A. ADMINISTRATIVE SHORT PLAT REPORT & DECISION

Project Name: Syrbu III Short Plat

File Number: LUA15-000766, SHPL-A

City of Renton
Syrbu III Short Plat
LAND USE ACTION NO. LUA-08-119-SHPL
LAND RECORD NO. LND-20-0531

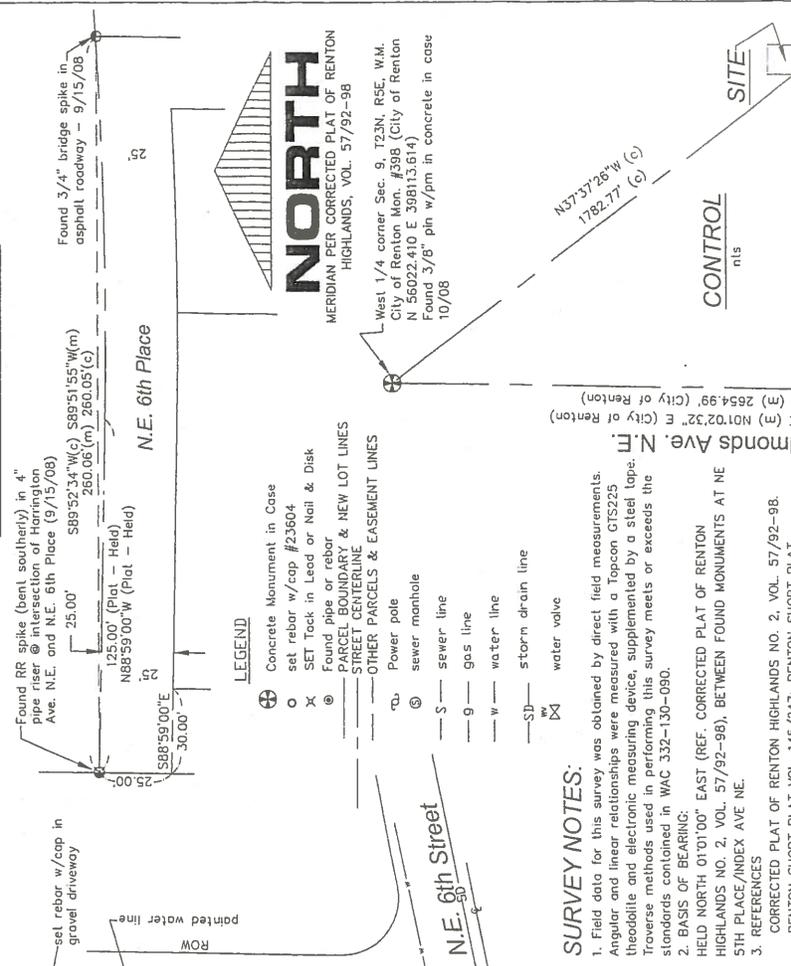
Note the new City of Renton land use action number and land record number, LUA15 000766 and LND 20 0531, respectively, on the final short plat submittal. The type size used for the land record number should be smaller than that used for the land use action number.

Provide short plat and lot closure calculations.

Do note encroachments, if any.

Do include a "LEGEND" block for the short plat drawing, detailing any symbols used thereon.

On the final short plat submittal, remove all references pertaining to utilities facilities, trees, concrete, gravel, decks and other items not directly impacting the subdivision. These items are provided only for preliminary approval.

NATALYA AND VYACHESLAV SYRBU
 SYRBU III SHORT PLAT
 UTILITIES/DRAINAGE/GRADING
 613 INDEX AVENUE NE

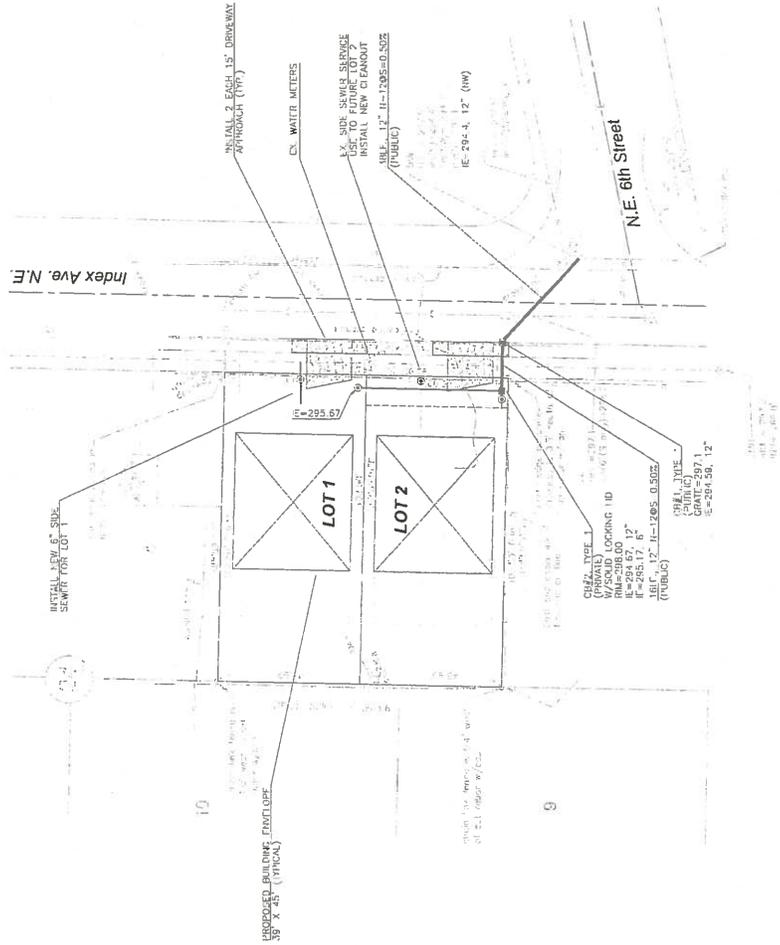
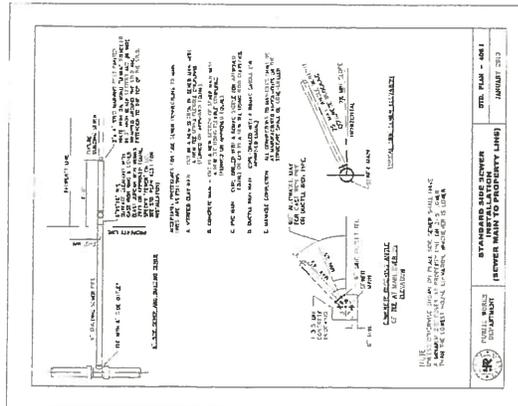
STORM There is a limited drainage conveyance system in Index Ave NE.

1. A drainage report dated October 20, 2015, prepared by Offe Engineers, was submitted with the site plan application. The report complies with the 2009 King County Surface Water Manual and the 2009 City of Renton Amendments to the KCSWM, Chapters 1 and 2. All core requirements have been discussed in the report. Based on the City's flow control map, this site falls within the Peak Rate Flow Control Standard, Existing Conditions. The project is exempt from flow control as the proposed two lot short plat will not create more than 0.10 cfs during the 100 year storm event in the developed condition. One existing home will be demolished and two new homes will be built on each new lot. As proposed, the two lot short plat is subject to Small Project Drainage Review. However, the project is required to install full frontage improvements including a minimum of a 12 inch storm line in Index Ave NE. This improvement will trigger Targeted Drainage Review. A revised TIR will be required at construction permit submittal.

2. A geotechnical report, dated August 21, 2015 was provided by Robert Pride PE, Geotechnical Engineer. Two test pit excavations were dug in the rear and front of the site. Results show soils found three to five feet in depth was fill material consisting of topsoil with fine silty sands and sands. The medium dense soil will support infiltration using infiltration trenches to collect the roof runoff and impervious surface area created from the new homes. An infiltration value of 25 min/inch should be used in the design and sizing of the facilities. The soils are suitable for limited infiltration.
